File Number: 9-C-25-IH

Location: 225 E. Oldham Ave. **Parcel ID:** 81 K H 020
Zoning: RN-2 (Single-Family Residential Neighborhood)
Description: After-the-fact revisions to 11-H-24-IH

After-the-fact revisions to COA 11-H-24-IH. Revisions include:

Elevations approved with permit

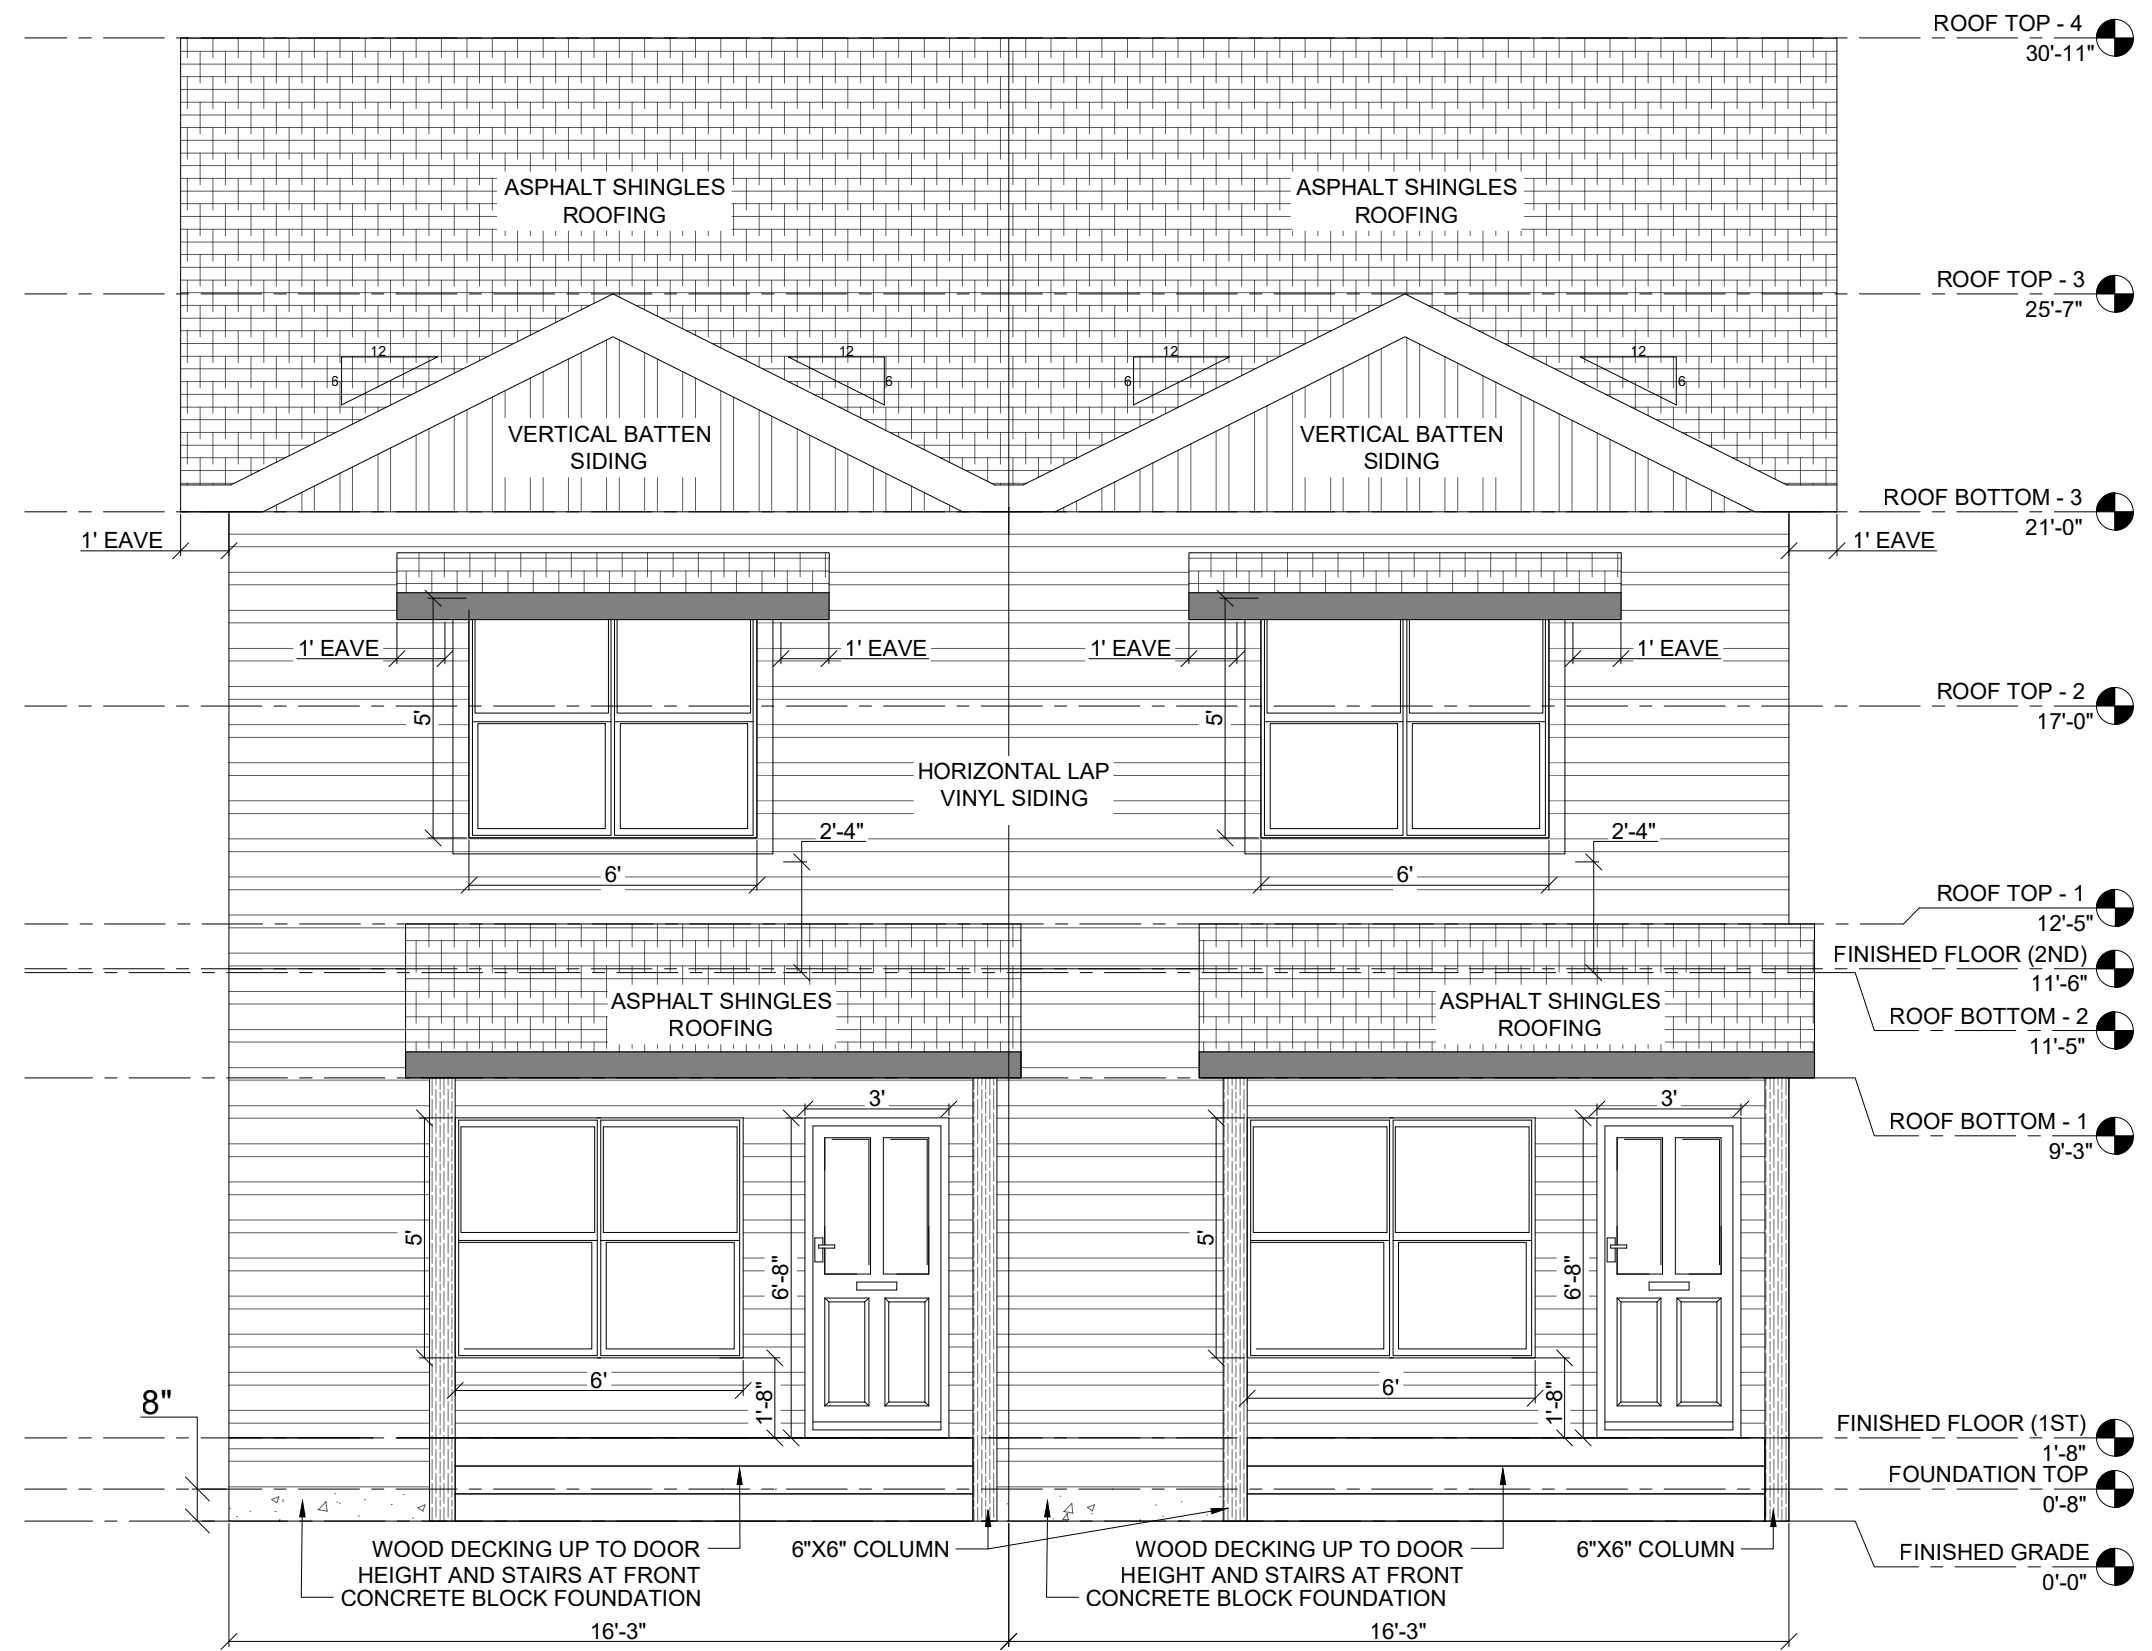
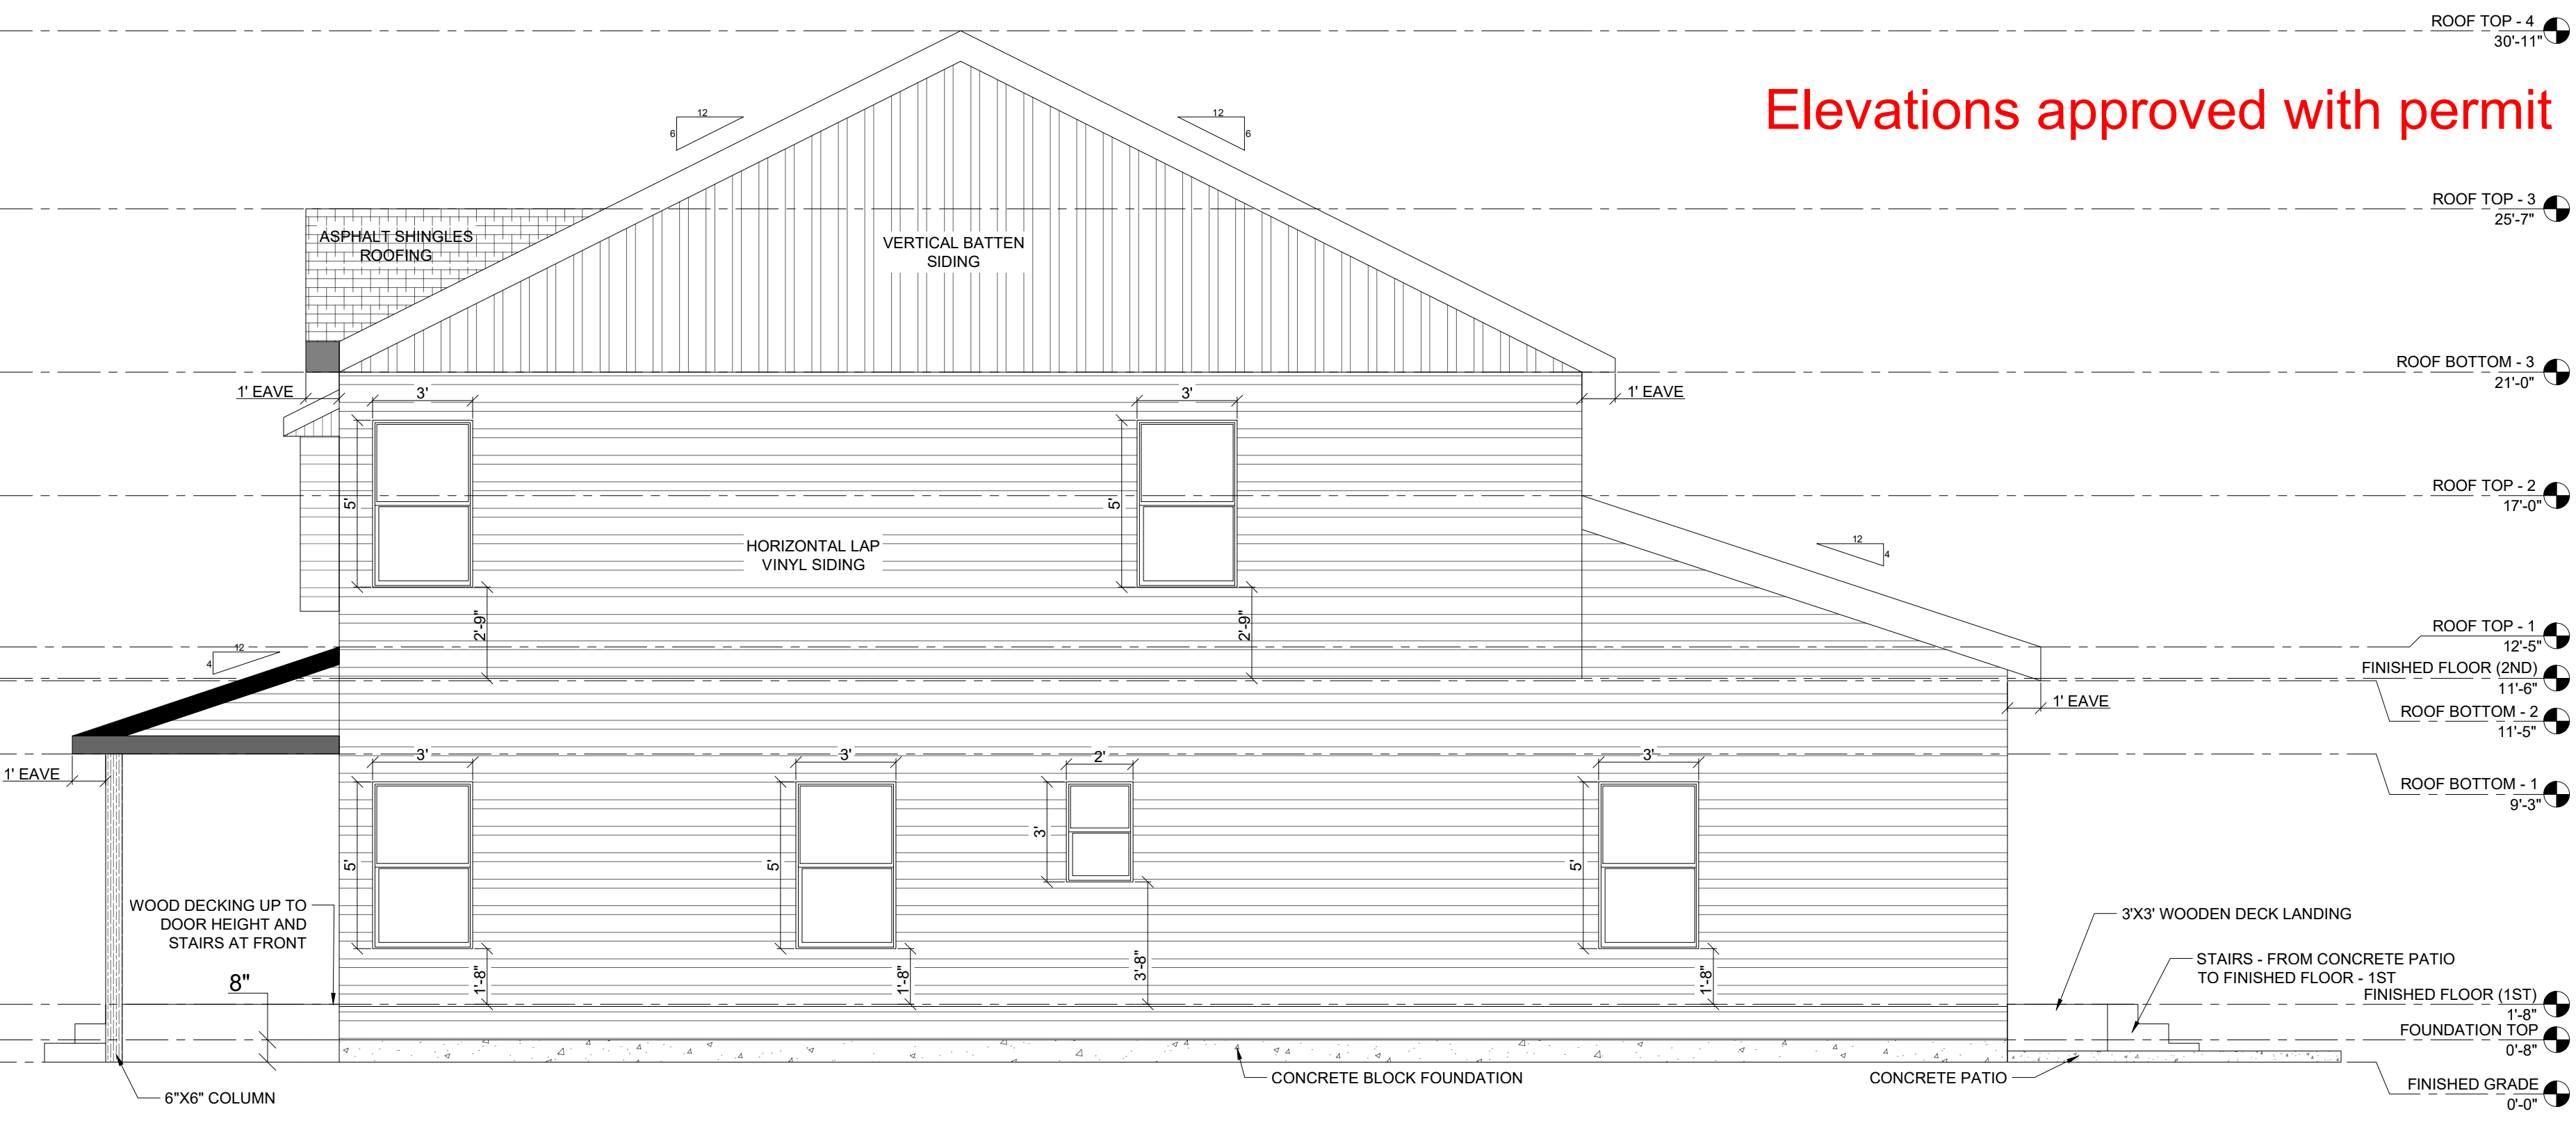
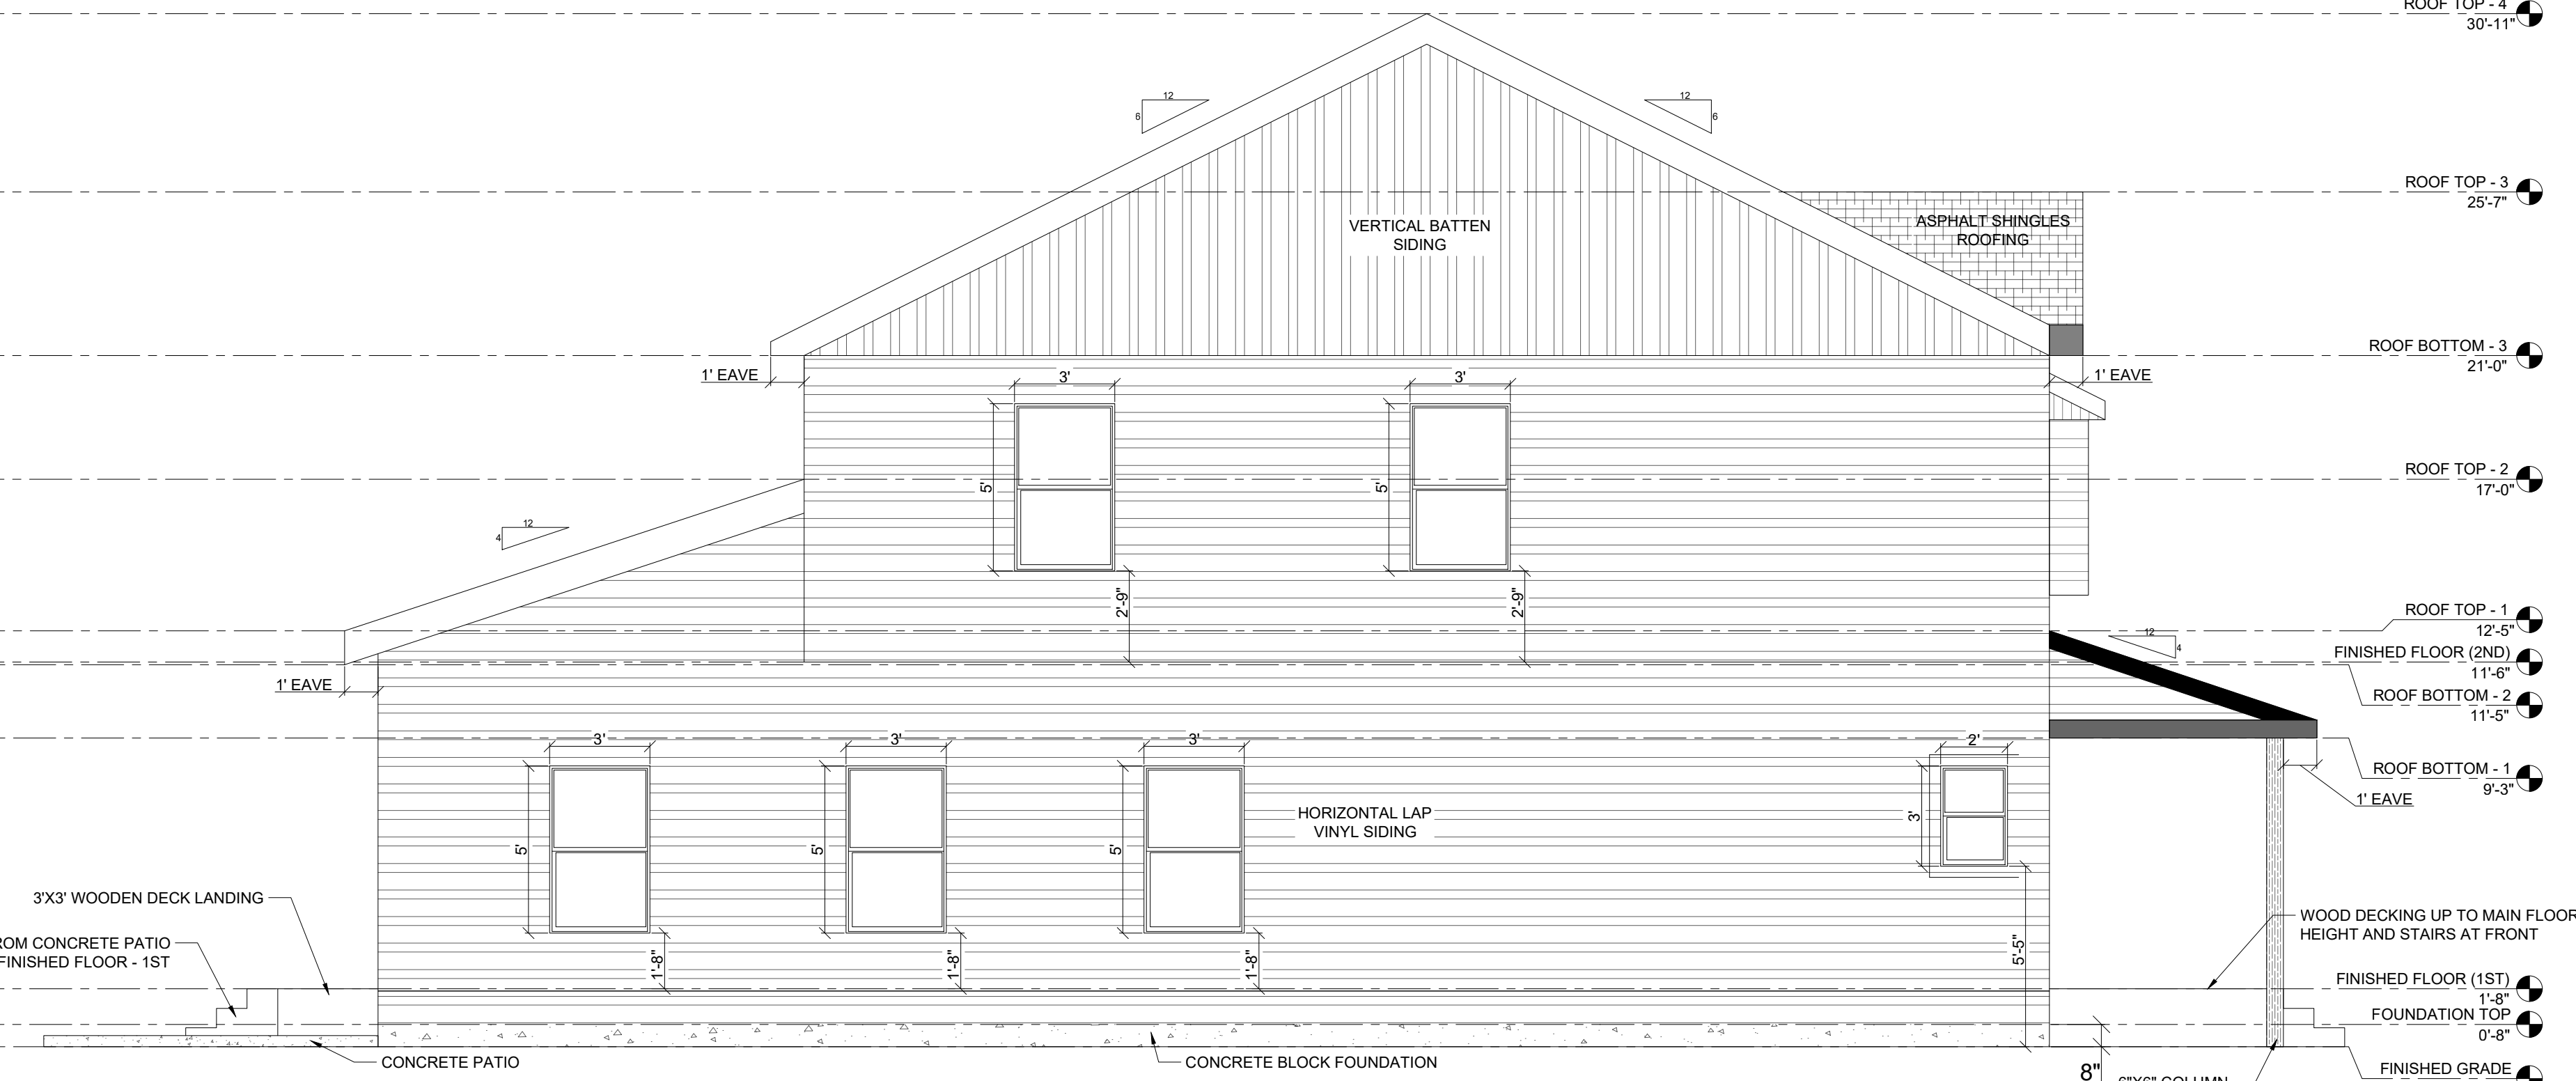
4. Design guidelines recommend that foundation heights “be comparable to historic houses in the neighborhood,” and most of the houses on this side of East Oldham Avenue feature raised foundations to account for the slope. The permit-approved plans included a 1’-8” tall foundation measured at the façade. The applicant reached out to staff in February soon after the permit was issued to request approval to increase the foundation to approximately 3.5’, which staff approved since the height was comparable to the other houses on the block. However, the building was constructed with a 7’ tall foundation at the façade, making the structure significantly tall in scale with the block that only features one-story houses. The Board should discuss whether shrubs (such as hydrangea, azaleas, rhododendron, or boxwood) should be planted at the sides of the foundation near the corners of the façade to screen the foundation, in addition to the proposed planter boxes.
